Location Address: 2328 JACKSON ST, HOLLYWOOD FL 33020
Lot(s): 13 Block(s): 4 Subdivision: HOLLYWOOD LITTLE RANCHES

Explanation of Request: NEW CONSTRUCTION 33 UNIT RENTAL APARTMENT BUILDING

SUBJECT: Preliminary Site Plan and Design review for 33 Residential Units.

PAVEMENT MARKINGS & SIGNAGE PLAN

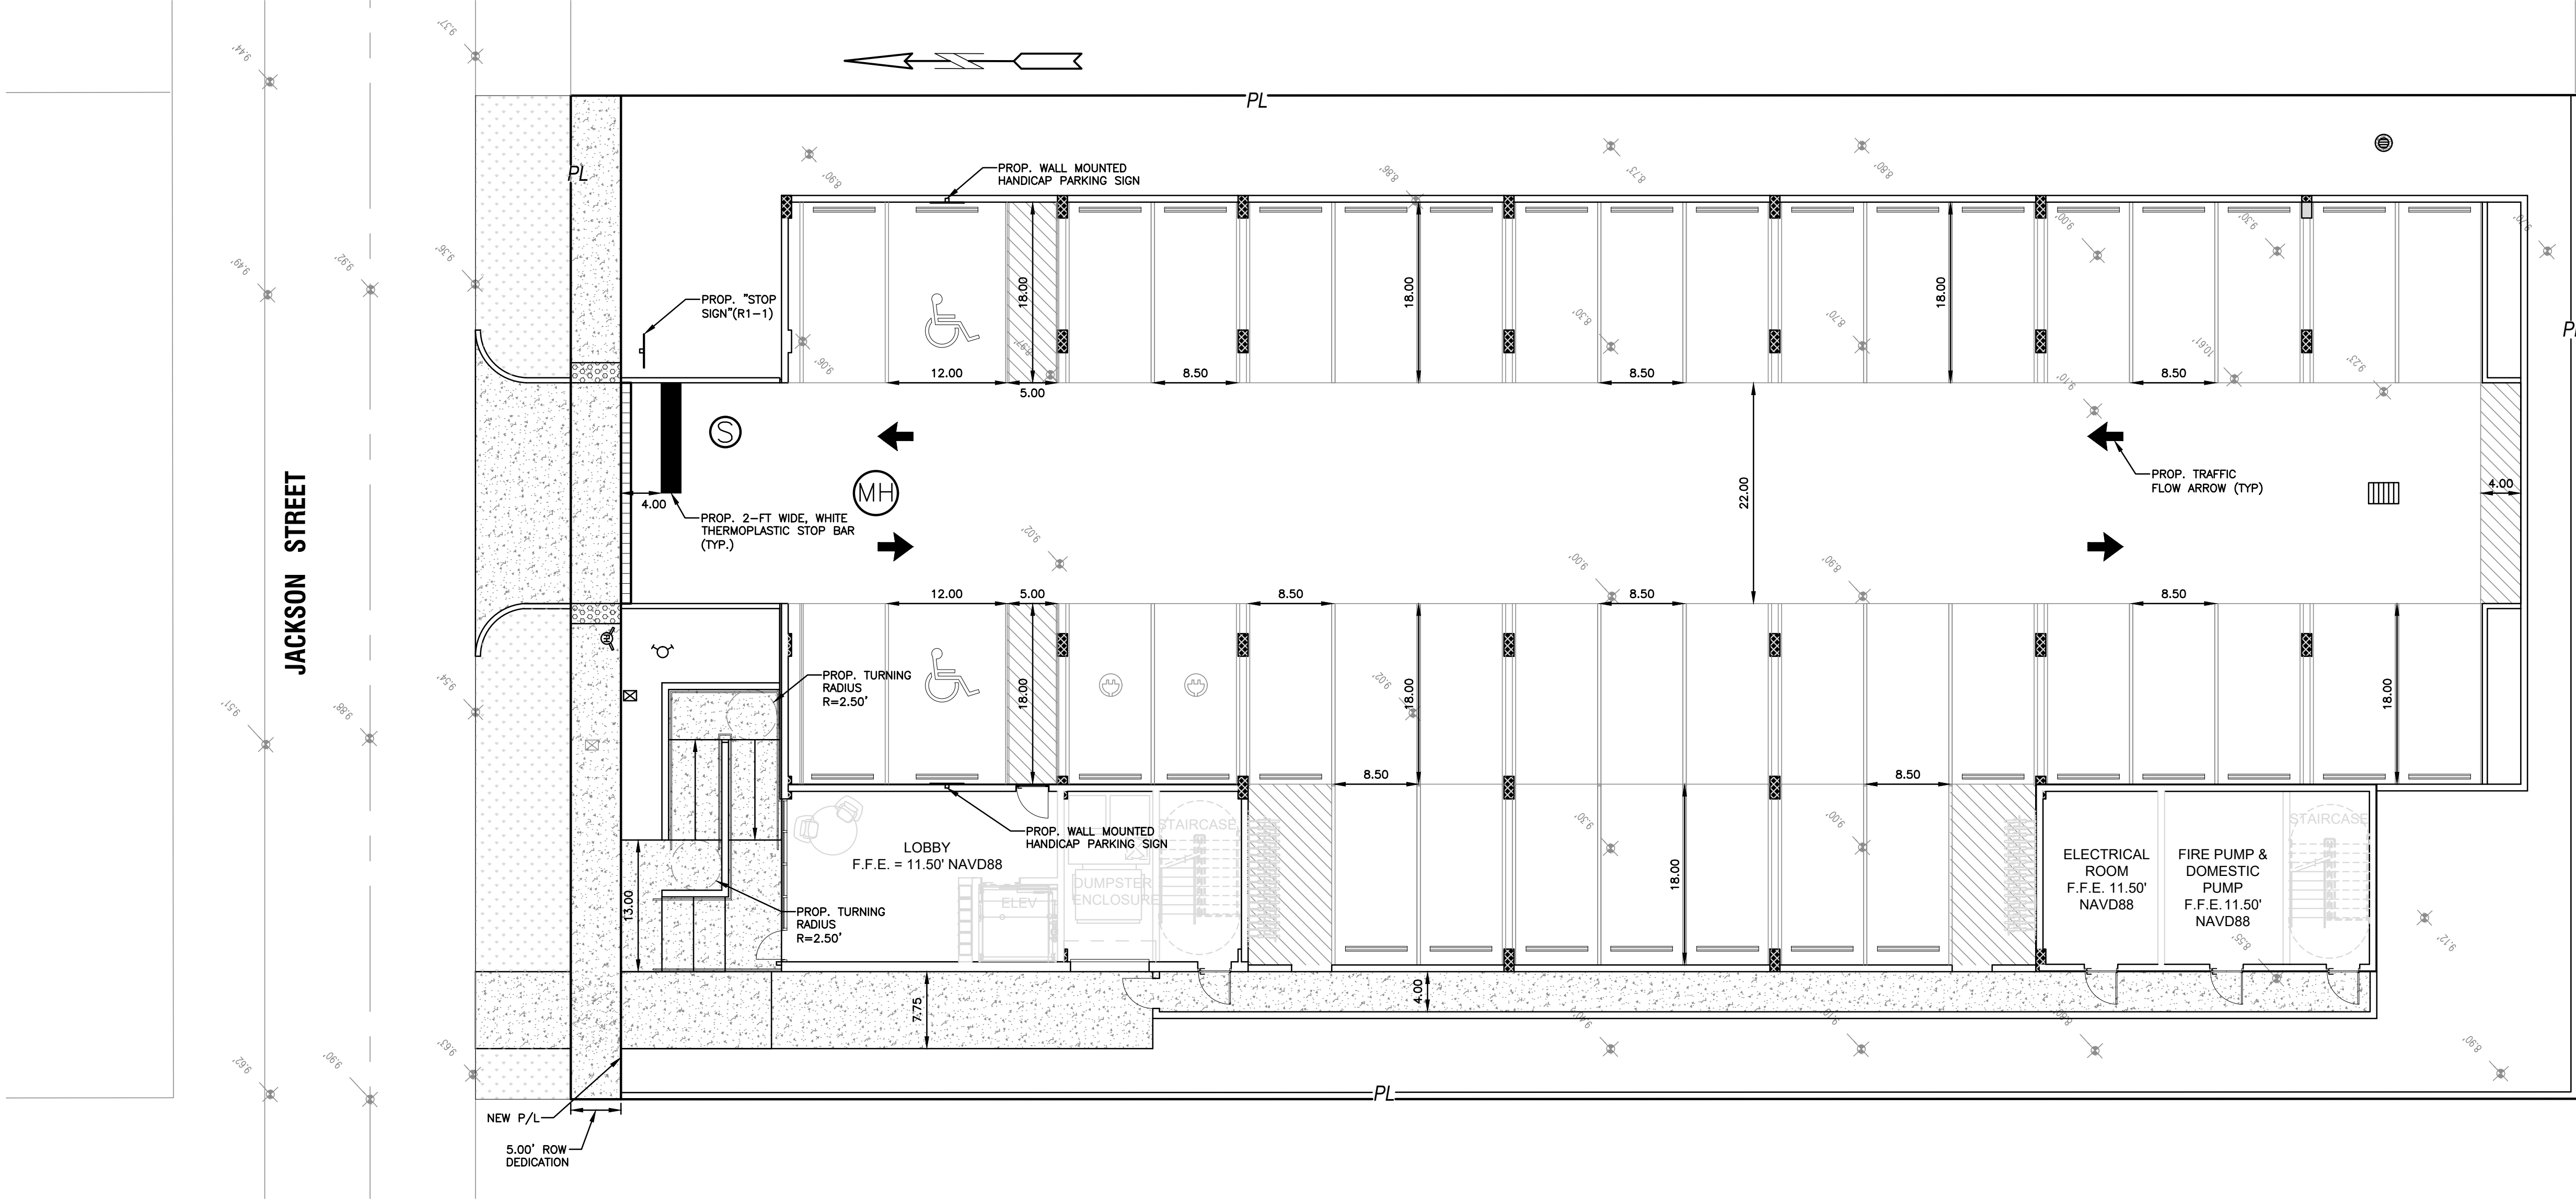
28. Please provide a pavement marking and signage plan for all onsite and off-site pavement markings. All pavement marking and signage within City rights-of-way requires review and stamped approved plans by Broward County Traffic Engineering Division. BCTED approval required at the time of permitting.

RESPONSE: Please see pavement markings and signage sheet C5. There aren't any R.O.W. pavement markings being impacted by this project.

C6

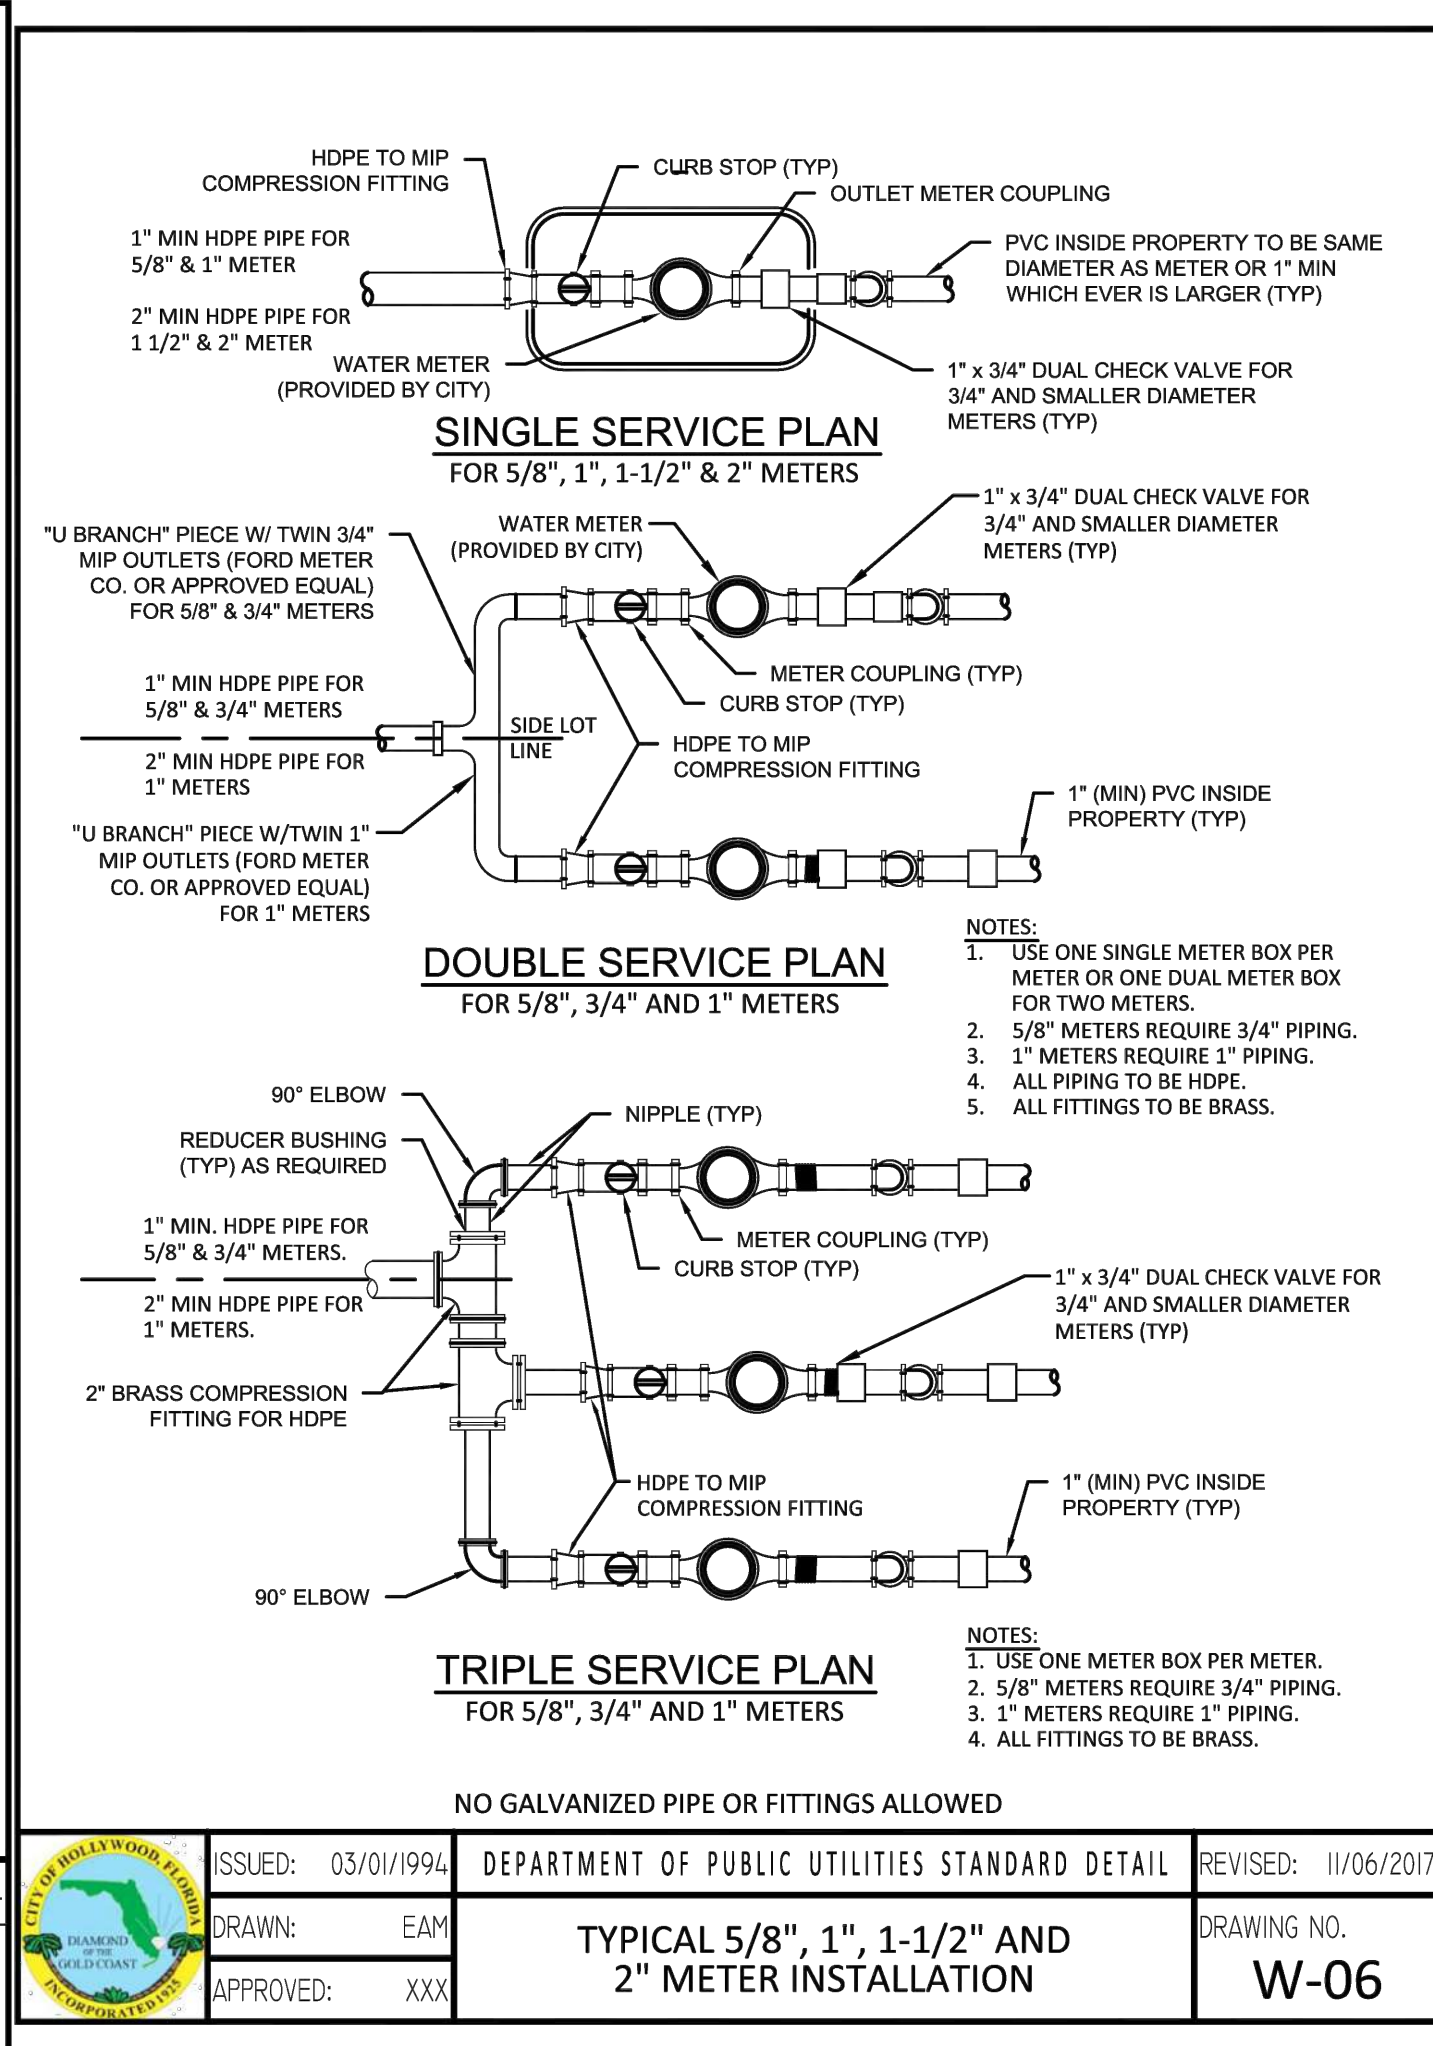
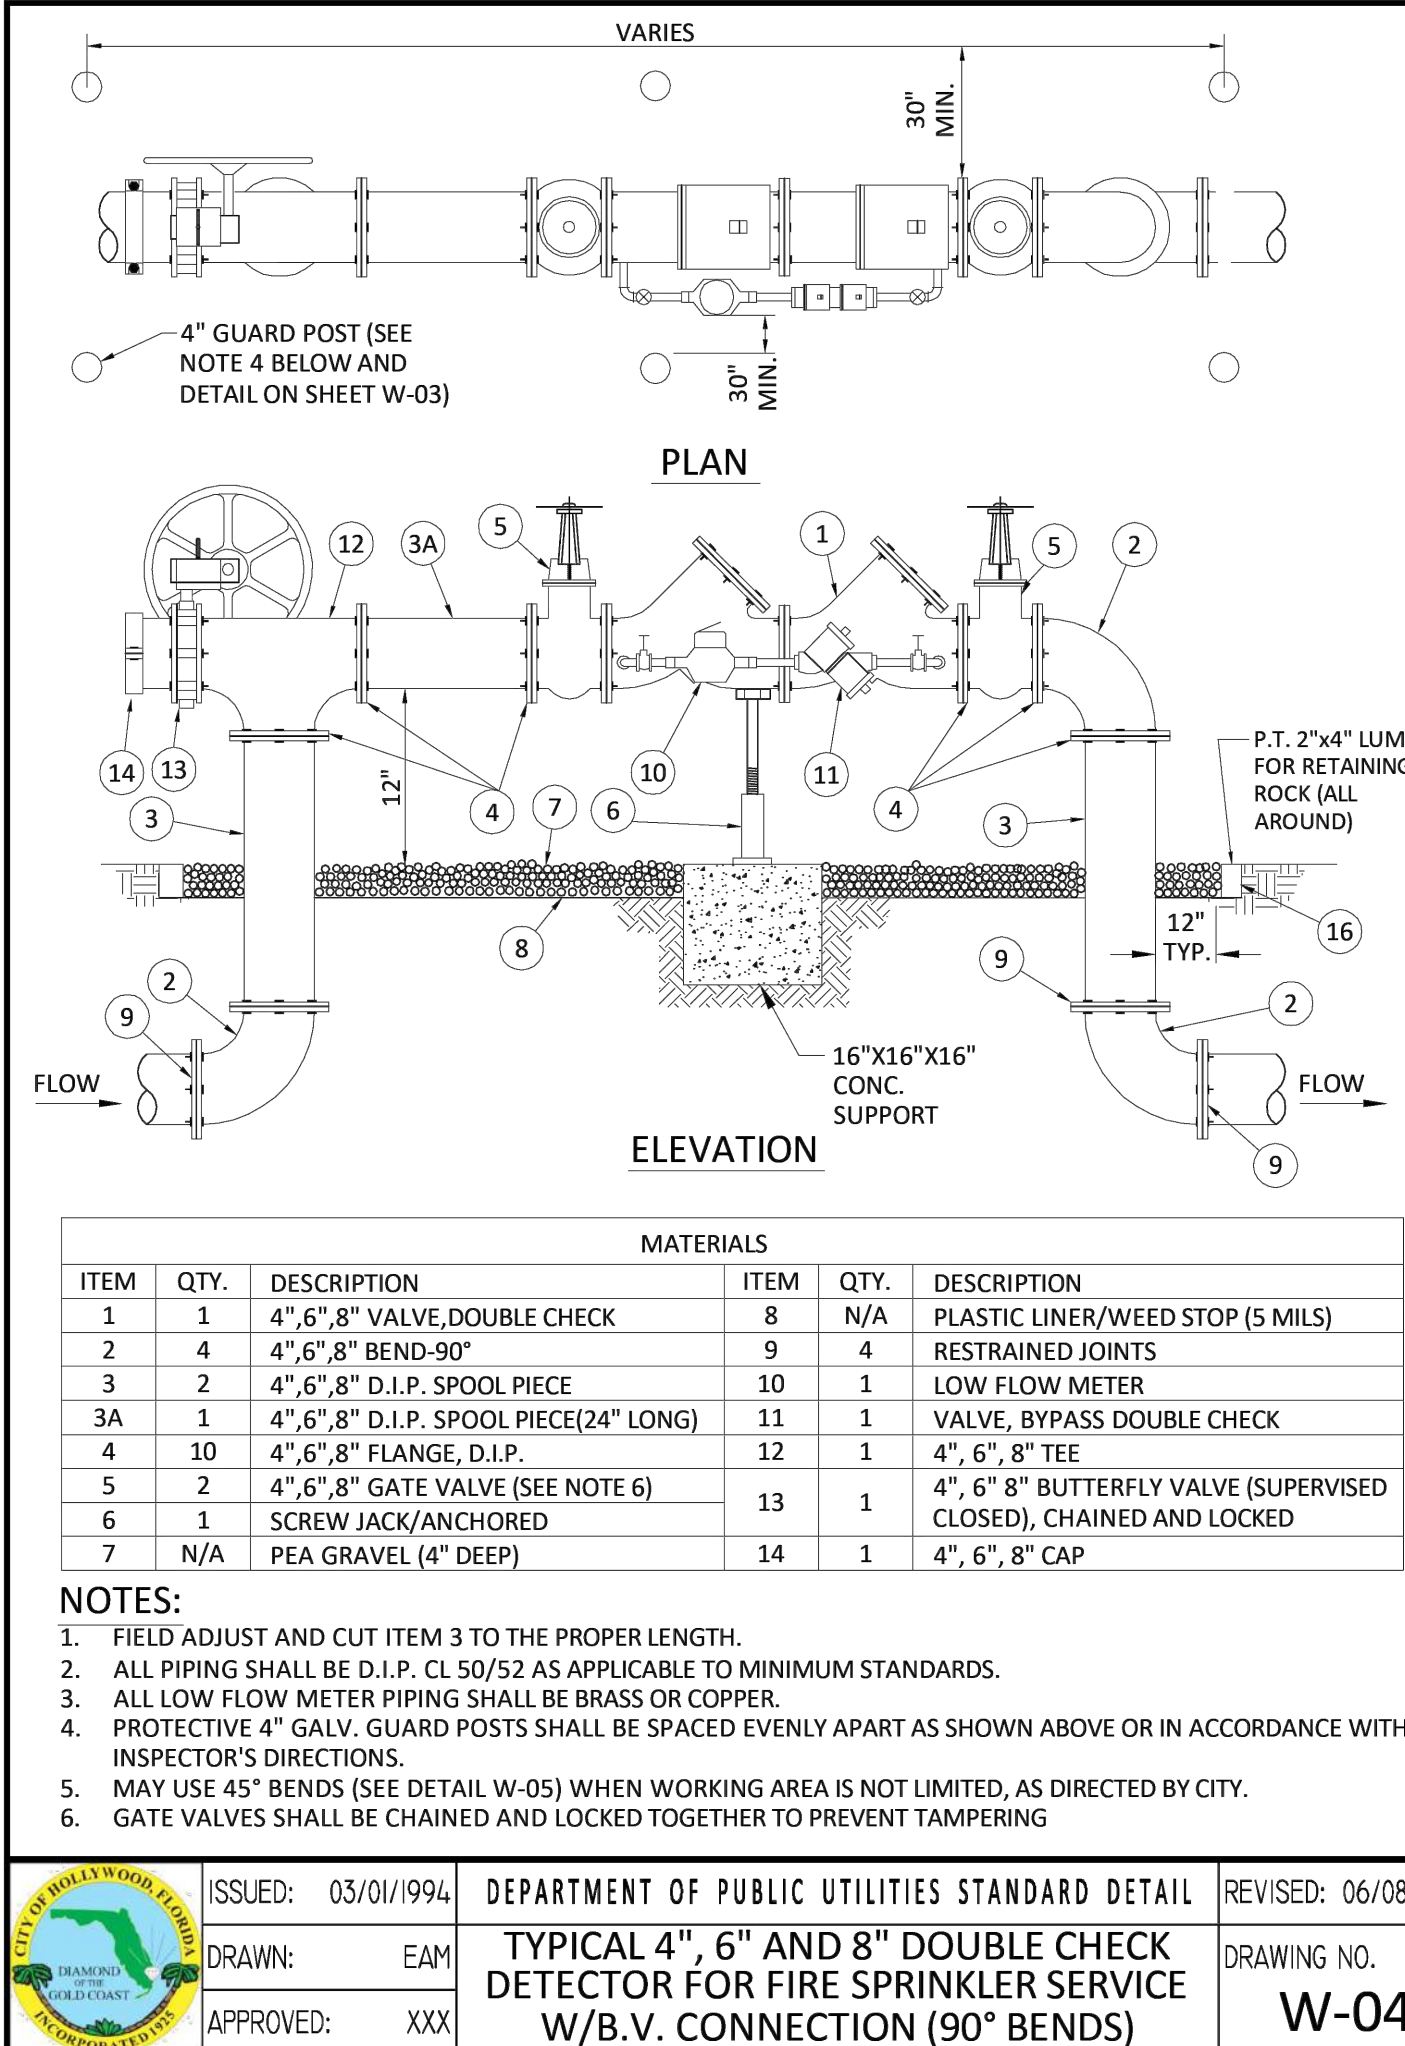
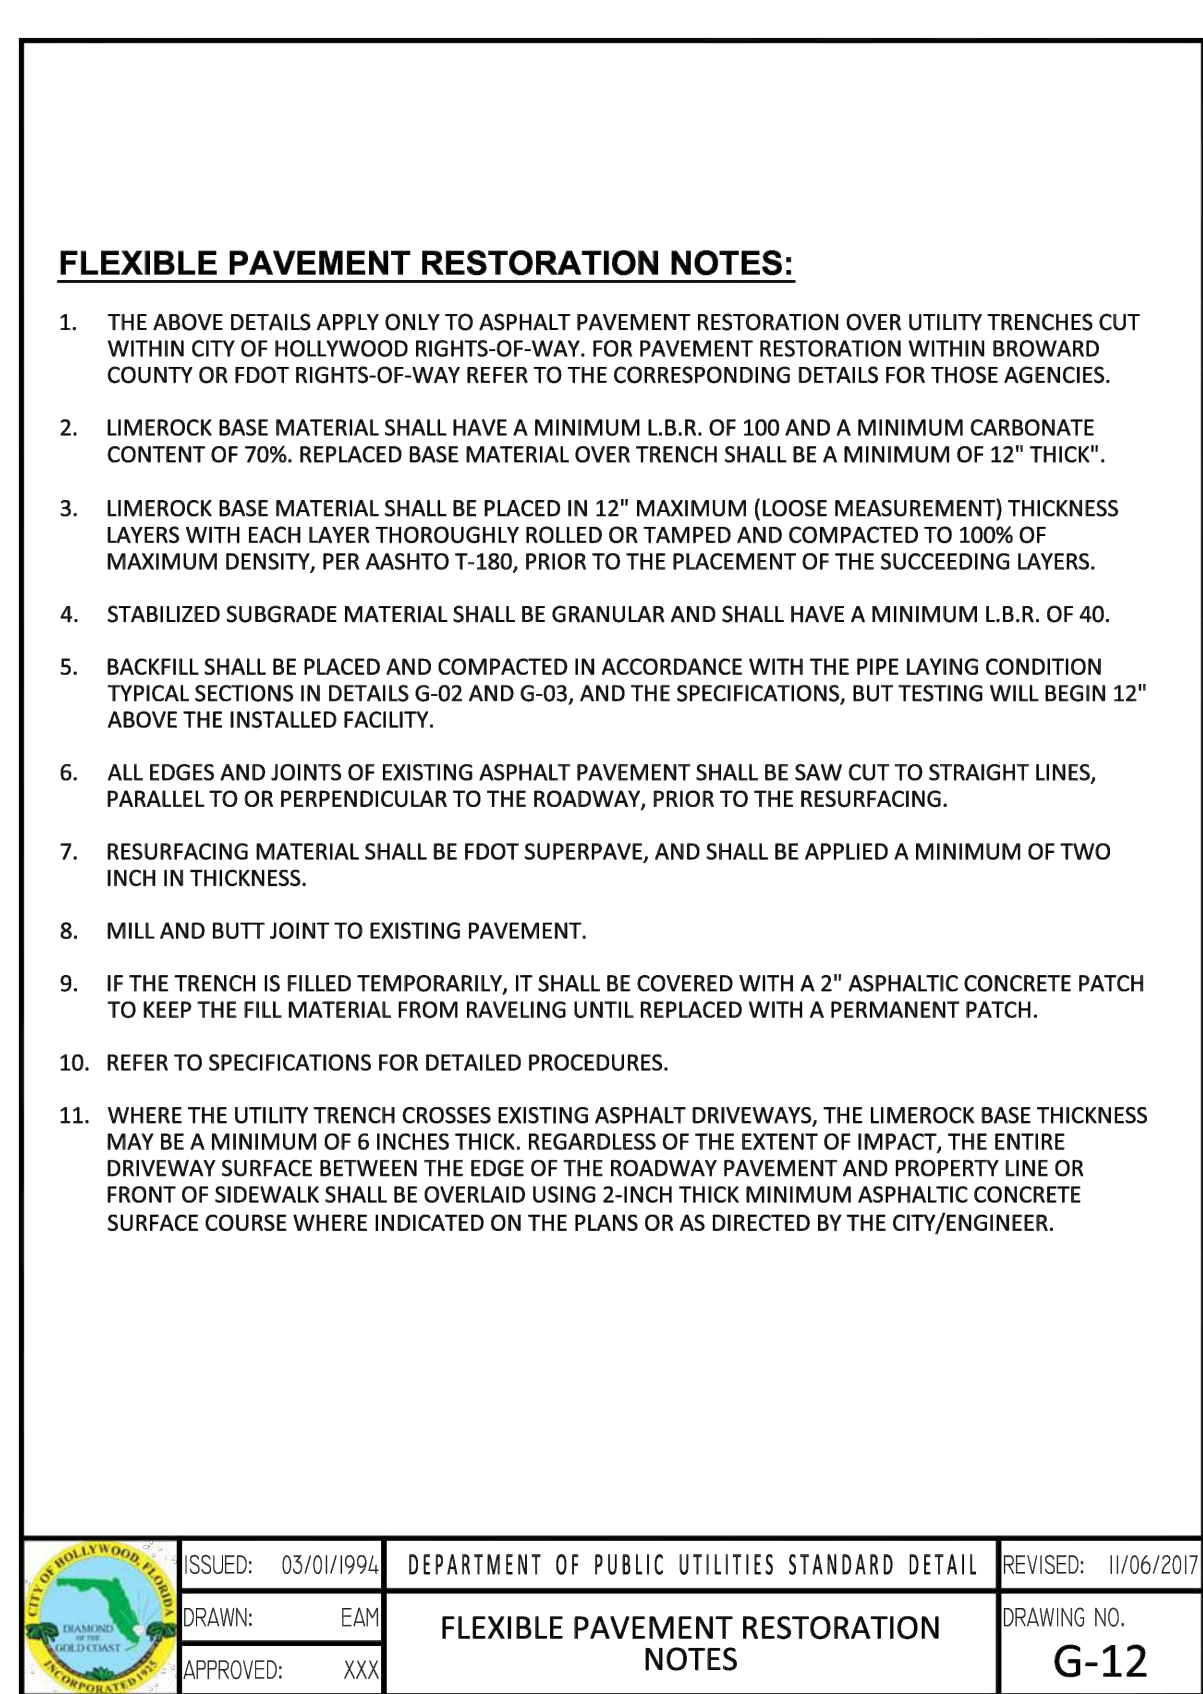
2. Provide civil drawings for the underground fire main. --- Provide such including the location of the fire department connection, DDCV, and size and type of the fire line from the water supply. --- Check with our water department for city requirements in addition to fire. --- Ensure on the plans that there is a fire hydrant within 100 feet of fire department connections as required by NFPA 14 (2016 Ed.) Section 6.4.5.4 --- "Fire department connections shall be located not more than 100 ft (30.5 m) from the nearest fire hydrant connected to an approved water supply."

3. Provide a note on civil drawing all underground fire main work must be completed by fire protection contractor holding a Class I, II, or V license per FS 633.102.

4. Water supply and any new hydrants shall be in place prior to accumulation of combustible materials per NFPA 1 (2018 Ed.) Section 16.4.3.1.1. --- Provide a note on the plans.

RESPONSE: Please see sheet C6.

RESPONSE: Please see note on sheet C6.

RESPONSE: Please see note on sheet C6.
